**Model  
Error Resolution Document**

1. Document Number:	MDL-NBS-HS-000020	2. Revision/Addendum:	REV02 AD 02	3. ERD:	ERD 04
4. Title:	Particle Tracking Model and Abstraction of Transport Processes				
5. No. of Pages Attached:	57

**6. Description of and Justification for Change (Identify affected pages, applicable CRs and TBVs):**  
 This ERD is prepared to evaluate the impact of changes to the thorium sorption coefficient distributions (which were recommended for the impact analysis in order to resolve CR11020 (MDL-NBS-HS-000008 REV02 AD01 ERD02, in preparation)) on the UZ transport calculations (*Particle Tracking Model and Abstraction of Transport Processes*, MDL-NBS-HS-000020 REV02 AD 02 [DIRS 184748]) that supported the TSPA-LA, and on the TSPA LA model.

Figure A-18. Comparison of Mean Annual Dose for the TSPA-LA Model to the Thorium  $K_d$  Changed Model for the EW 10, 000-Year Modeling Case. Note: the base case is red line and the sensitivity case is black dashed line.

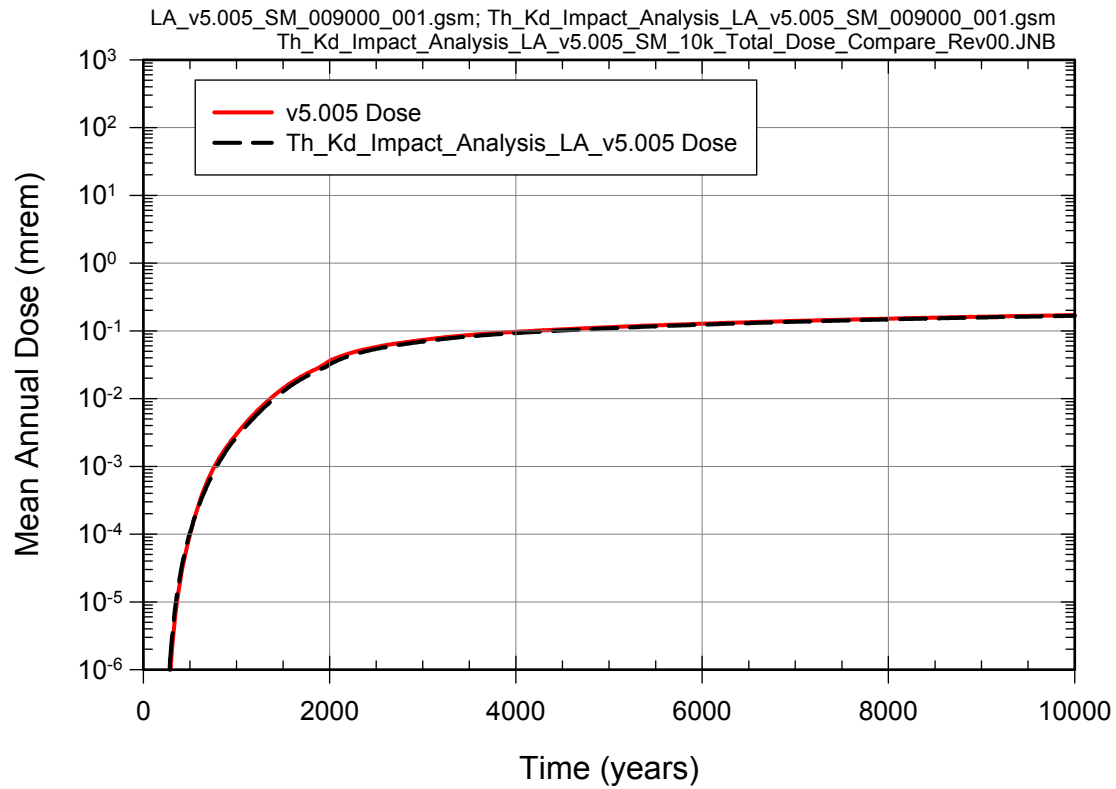
Figure A-18 is a plot of mean annual dose for the EW 10,000-year modeling case. As discussed above in Section A-3, for 10,000-year modeling cases,  $^{230}\text{Th}$ ,  $^{232}\text{Th}$ ,  $^{226}\text{Ra}$ , and  $^{228}\text{Ra}$  are not considered in dose calculations. The negligible dose changes depicted in Figure A-18 reflect changes in the dose contribution from  $^{229}\text{Th}$ , which is a small contributor to dose as shown in SNL 2008 [DIRS 183478], Figure 8.2-6[a].

Figure A-19. Comparison of Mean Annual Dose for the TSPA-LA Model to the Thorium  $K_d$  Changed Model for the SM 10, 000-Year Modeling Case. Note: the base case is red line and the sensitivity case is black dashed line.

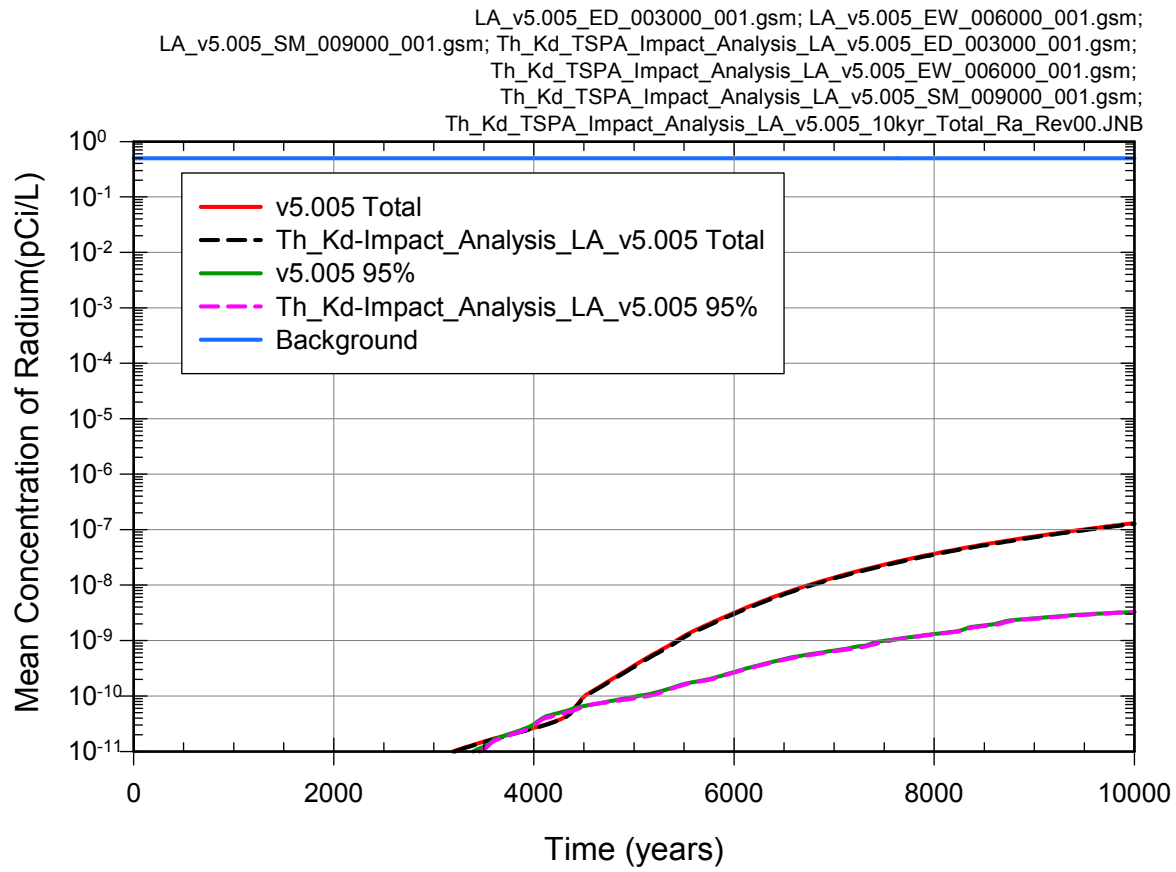
Figure A-19 is a plot of mean annual dose from the 10,000-year SM modeling case, showing that the thorium  $K_d$  changes have little impact on mean annual dose. As discussed above in Section A.3, for 10,000-year modeling cases,  $^{230}\text{Th}$ ,  $^{232}\text{Th}$ ,  $^{226}\text{Ra}$ , and  $^{228}\text{Ra}$  are not considered in dose calculations. The negligible dose changes depicted in Figure A-19 reflect changes in the dose contribution from  $^{229}\text{Th}$ , which is a small contributor to dose as shown in SNL 2008 [DIRS 183478], Figure 8.2-12[a].

Figure A-20. Comparison of combined Total Radium ( $^{226}\text{Ra}$  and  $^{228}\text{Ra}$ ) Concentrations between the TSPA-LA Model and the Thorium  $K_d$  Changed Model. Note: the base cases are solid red and green lines and the sensitivity cases are black and pink dashed lines, respectively.

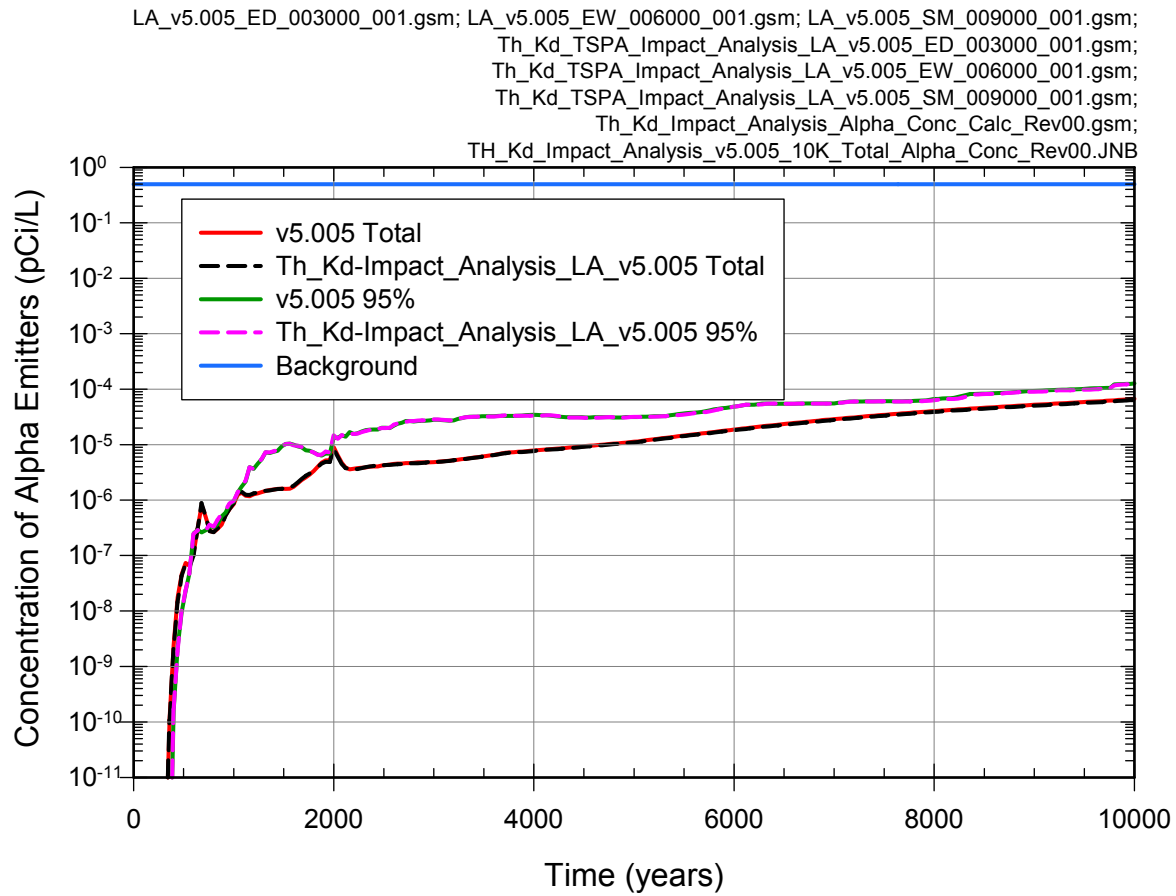
The mean activity concentration of radium from the TSPA-LA model was also evaluated for the impact of changing the thorium  $K_d$  distributions. As can be seen in Figure A-20, a comparison of the mean values of total radium concentration, which are based on the summation of the mean  $^{226}\text{Ra}$  and  $^{228}\text{Ra}$  concentrations from the 10,000-year ED, EW and SM Modeling Cases, shows that the impact of changing the thorium  $K_d$  distributions is negligible. Thus conclusions based on the mean activity concentrations of radium presented in the TSPA-LA AMR (SNL 2008 [DIRS 183478], Section 8.1.2.1[a]) would be unaffected by the changes in the thorium  $K_d$  distributions for devitrified and vitrified tuffs. Likewise, the mean activity concentration of alpha-emitters from the TSPA-LA model was also evaluated for the impact of changing the thorium  $K_d$  distributions. As can be seen in Figure A-21, a comparison of the mean values of alpha-emitter concentration, which are based on the summation of the mean alpha-emitter concentrations from the 10,000-year ED, EW and SM Modeling Cases, shows that the impact of changing the thorium  $K_d$  distributions is negligible. Thus conclusions based on the mean activity concentrations of alpha-emitters presented in the TSPA-LA AMR (SNL 2008 [DIRS 183478], Section 8.1.2.2[a]) would be unaffected by the changes in the thorium  $K_d$  distributions for devitrified and vitrified tuffs.

Figure A-22. Comparison of Mean Annual Dose for a Single CSNF waste package and a Single waste package with a Naval Source Term for the ED Modeling Case (From SNL 2008 [DIRS 183478], Figure 7.5-4[a])

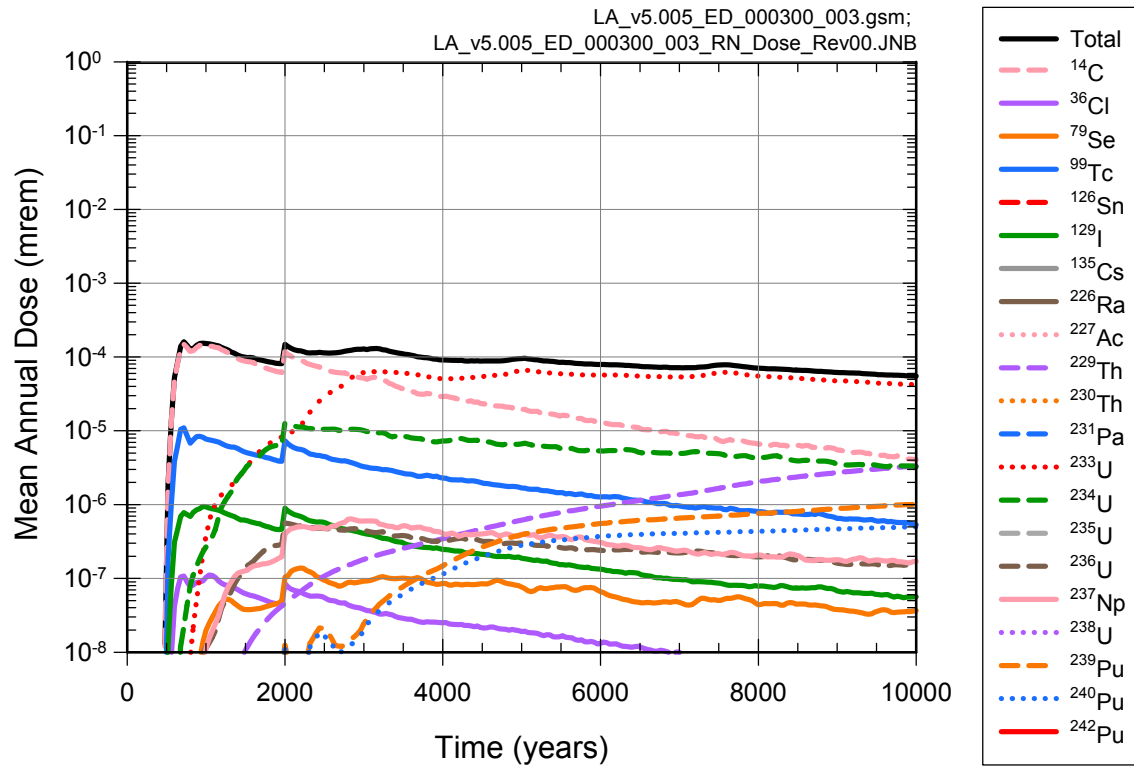
An examination of the mean annual doses of the 10,000-year ED Modeling Case presented in Figure A-22 indicates that the use of a CNSF waste package as a surrogate is a conservative choice with the mean annual dose from the surrogate waste package simulation over two orders of magnitude greater than that of the NSNF waste package simulation. Figure A-23 shows that for the NSNF waste package simulation the maximum percentage contribution of  $^{229}\text{Th}$  (which occurs at 10,000 years) to the mean annual dose is approximately 6% ( $3.34 \times 10^{-6}$  mrem vs.  $5.51 \times 10^{-5}$  mrem). Thus, for the NSNF waste package simulation, only a large change in the contribution from  $^{229}\text{Th}$  would have a significant effect on the mean annual dose (doubling the maximum percentage contribution of  $^{229}\text{Th}$ , at 10,000 years, would only increase the total mean annual dose by another 6%). For the CNSF waste package simulation (see Figure A-24), the maximum percentage contribution of  $^{229}\text{Th}$  to the mean annual dose is approximately 0.008% ( $7.73 \times 10^{-7}$  mrem vs.  $9.82 \times 10^{-3}$  mrem), which means that for the CNSF waste package simulation only a large change in the contribution from  $^{229}\text{Th}$  would have a significant effect on the mean annual dose (multiplying the contribution of  $^{229}\text{Th}$  at 10,000 years by a factor of 126 would only increase the original total mean annual dose by 1% at 10,000 years). Section A.3.4 presents a comparison of the ED 10,000-year modeling case mean annual dose results for the two different sets of thorium  $K_d$ s. Although these simulations included both CDSP and CSNF waste, it is expected that the negligible difference in mean annual dose (see Figure A-17) is indicative of the degree of change that would be seen for a single CSNF waste package release. This expectation is based on the consideration that the maximum  $^{229}\text{Th}$  dose contribution in the 10,000-year ED Modeling Case for a single CSNF waste package (which occurs at 10,000 years) has a mean annual contribution of  $^{229}\text{Th}$  to dose that is 0.008% ( $7.73 \times 10^{-7}$  mrem vs.  $9.82 \times 10^{-3}$  mrem) of the mean annual total dose (Figure A-24). In comparison, the maximum percentage  $^{229}\text{Th}$  dose contribution in the 10,000-year TSPA-LA ED Modeling Case (which also occurs at 10,000 years) has a mean annual contribution of  $^{229}\text{Th}$  to dose that is 0.006% ( $3.77 \times 10^{-9}$  mrem vs.  $6.32 \times 10^{-5}$  mrem) of the mean annual total dose (SNL 2008 [DIRS 183478], Figure 8.2-4[a] and DTN: MO0710PLOTSFIG.000 [DIRS 185207]). Since these two percentages are similar in order of magnitude the simulations described in Section A.3.4 are good analogues for the case of a single CSNF waste package. In addition, since the mean annual dose from the CSNF waste package simulation is approximately two orders of magnitude greater than the mean annual dose from the NSNF waste package simulation (Figure A-22), it is unlikely that any conclusions about the validity of using CSNF waste packages as surrogates for the NSNF waste packages will be impacted by the change in thorium  $K_d$ s.

Figure A-25. Comparison of Mean Annual Dose for a Single CSNF waste package and Single waste package with a Naval Source Term for the IG Modeling Case (From SNL 2008 [DIRS 183478], Figure 7.5-5[a])

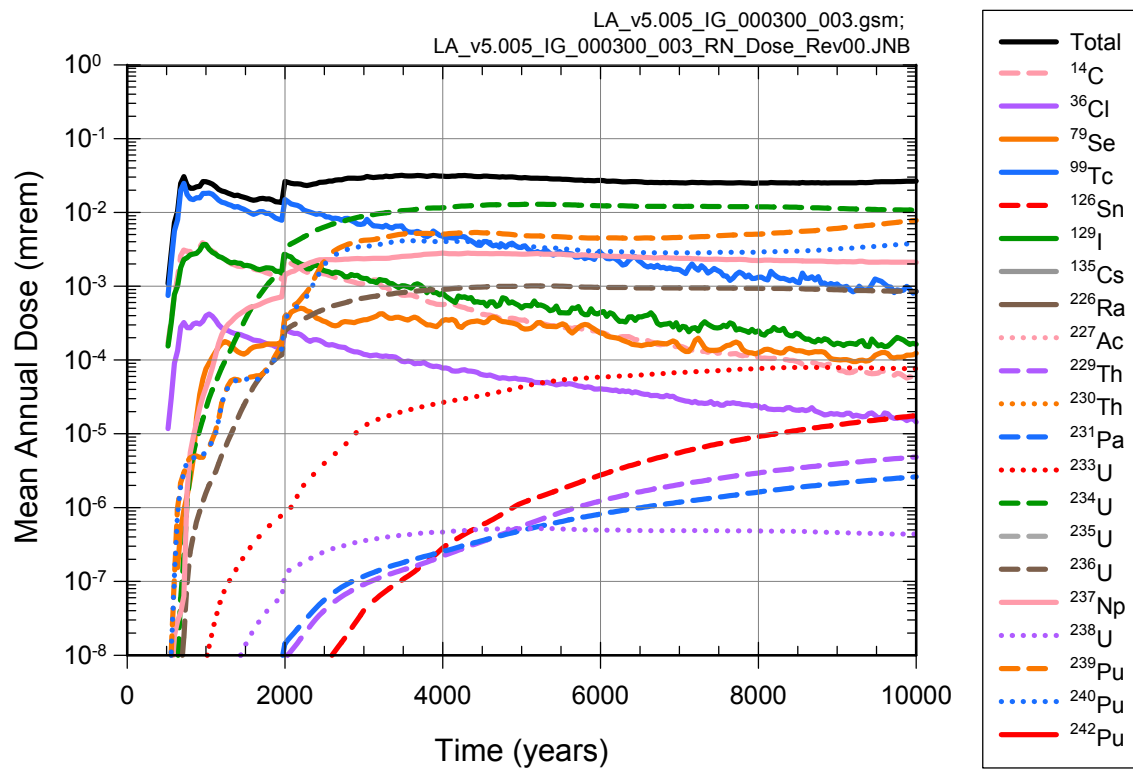
An examination of the mean annual doses of the 10,000-year IG analysis presented in Figure A-25 shows that the use of a CNSF waste package as a surrogate is a conservative choice but not to the extent shown in the ED analysis. Figure A-26 shows that for the NSNF waste package

Figure A-26. Contribution to Mean Dose from a Single waste package with a Naval Source Term for the IG Modeling Case

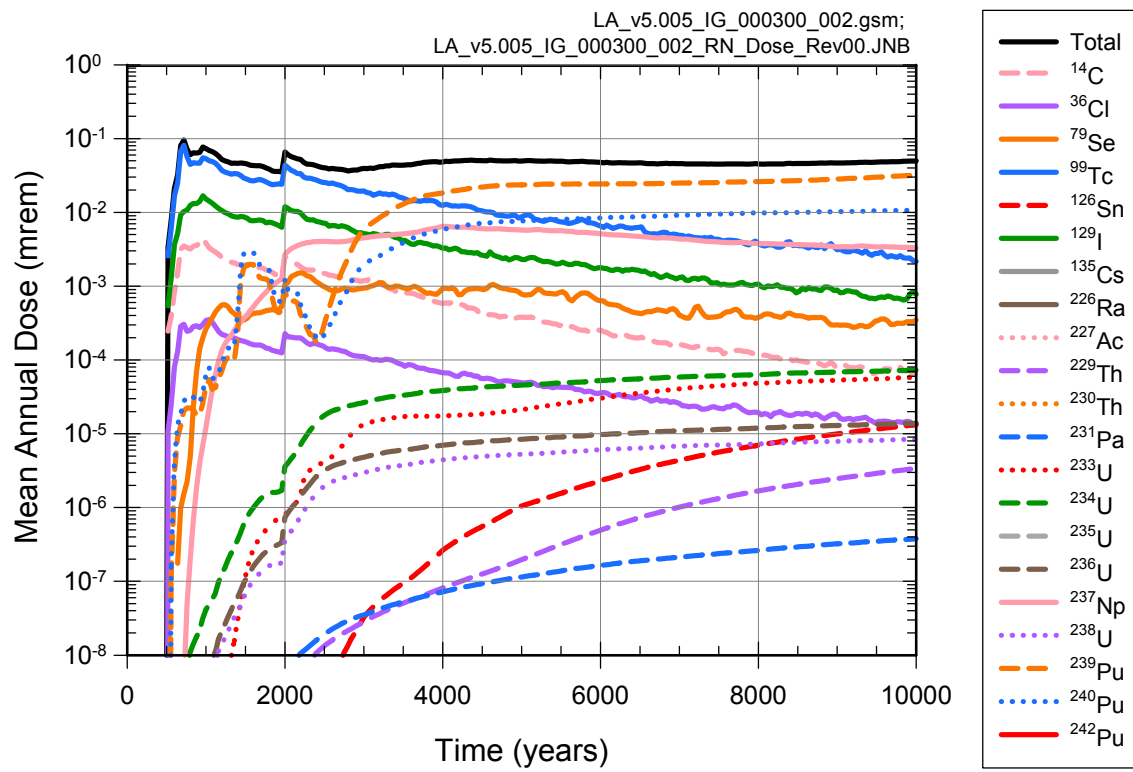
simulation the maximum percentage contribution of  $^{229}\text{Th}$  to the mean annual dose is approximately 0.02% ( $4.85 \times 10^{-6}$  mrem vs.  $2.66 \times 10^{-2}$  mrem). This means that you would have to multiply the contribution of  $^{229}\text{Th}$  by a factor of 51 to increase the original total dose by 1%. For the CNSF waste package simulation (see Figure A-27), the maximum percentage contribution of  $^{229}\text{Th}$  to the mean annual dose is approximately 0.007% ( $3.37 \times 10^{-6}$  mrem vs.  $4.96 \times 10^{-2}$  mrem). This means that you would have to multiply the contribution of  $^{229}\text{Th}$  by a factor of 144 to increase the original total dose by 1%. For both the CNSF waste package and NSNF waste package simulations a change in the dose contribution from  $^{229}\text{Th}$  would have a negligible effect on the mean annual dose results unless the increase was large. In addition, Section A.3.1 presents a comparison of the IG one-million-year modeling case mean annual dose results for the two different sets, of thorium  $K_d$ s, that can be used as an analogue for the single CSNF single waste package release. Although this is not a 10,000 year simulation, the mean annual dose results at 10,000 years for the one-million year IG base case are similar to the results for the 10,000 year base case. The total mean annual doses for the 10,000 year IG case and one-million-year IG case are 0.0661 mrem and 0.0660 mrem respectively (SNL 2008 [DIRS 183478], Figure 8.2-8[a] and DTN: MO0710PLOTSFIG.000 [DIRS 185207]). The total mean annual dose contributions of  $^{229}\text{Th}$  for the 10,000 year IG case and one-million-year IG case are  $5.7 \times 10^{-6}$  mrem and  $4.8 \times 10^{-6}$  mrem respectively (SNL 2008 [DIRS 183478], Figure 8.2-8[a] and DTN: MO0710PLOTSFIG.000 [DIRS 185207]). Although the IG one-million-year modeling case simulations included both CDSP and CSNF waste, it is expected that the negligible difference in mean annual dose (see Figure A-28) is indicative of the degree of change that would be seen for a single CSNF waste package release. This expectation is based on the consideration that the maximum  $^{229}\text{Th}$  dose contribution in the 10,000-year IG Modeling Case for a single CSNF waste package (which occurs at 10,000 years) has a mean annual contribution of  $^{229}\text{Th}$  to dose that is approximately 0.007 % ( $3.37 \times 10^{-6}$  mrem vs.  $4.96 \times 10^{-2}$  mrem) of the mean annual total dose (Figure A-27). In comparison, the maximum percentage  $^{229}\text{Th}$  dose contribution in the one-million-year TSPA-LA IG Modeling Case (which also occurs at 10,000 years) has a mean annual contribution of  $^{229}\text{Th}$  to dose that is approximately 0.007 % ( $4.80 \times 10^{-6}$  mrem vs.  $6.60 \times 10^{-2}$  mrem) of the mean annual total dose (SNL 2008 [DIRS 183478], Figure 8.2-8[a] and DTN: MO0710PLOTSFIG.000 [DIRS 185207]). Since these two percentages are approximately the same, the simulations described in Section A.3.1 are good analogues for the case of a single CSNF waste package.
